## Planning, Land Use and Mobility Committee Case Report

**Case Nos:** DIR-2024-700-DRB-SPPC-HCA, ENV-2024-701

**Site Location:** 22025 W San Miguel Street, Woodland Hills, 91364

**Project:** Project Descriptions(s): Pursuant to LAMC 11.5.7 and 16.50, a major project compliance with design review within the Mulholland Scenic Parkway Specific Plan for remodeling and second story addition to existing single story, single-family detached home. Demolition of partial carport, new trellis/wall added, a new pool, a new front porch, balconies and attached ADU. New construction equals 2,153 square feet. Remodel includes demolition of various existing structures. Includes exterior renovation and alteration.

# Landscape Design

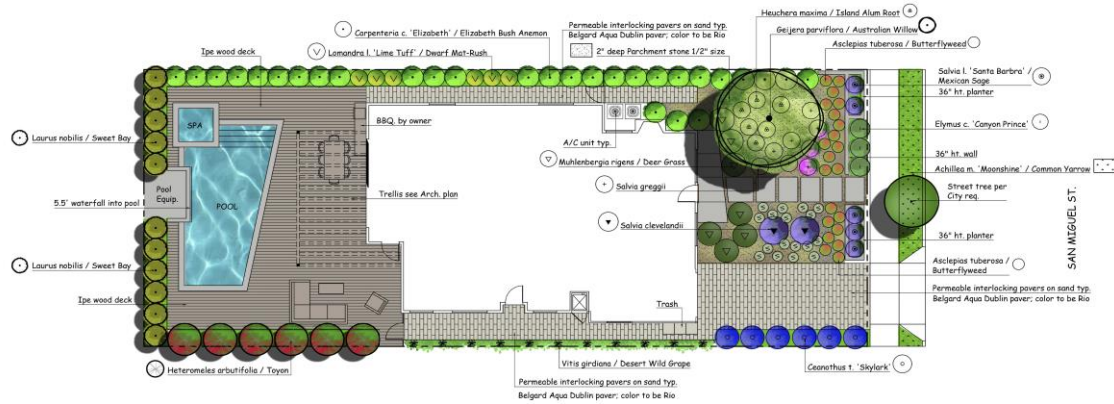
- Applicant to verify if the 2<sup>nd</sup> floor flat roofs are to be used as future roof decks (concern for the neighboring parties)
- Applicant to label planting around pool equipment for sound buffer at rear yard (per landscape plan)

- The landscape/hardscape plan shows new permeable pavers for driveway and side yard pedestrian access. The entry pavers are spaces with landscape grout lines and miscellaneous planting. The rear yard has a new pool and spa, with open beam patio trellis and IPE wood decking All side yards have slender row of consistent planting to screen and contain privacy for the applicants.
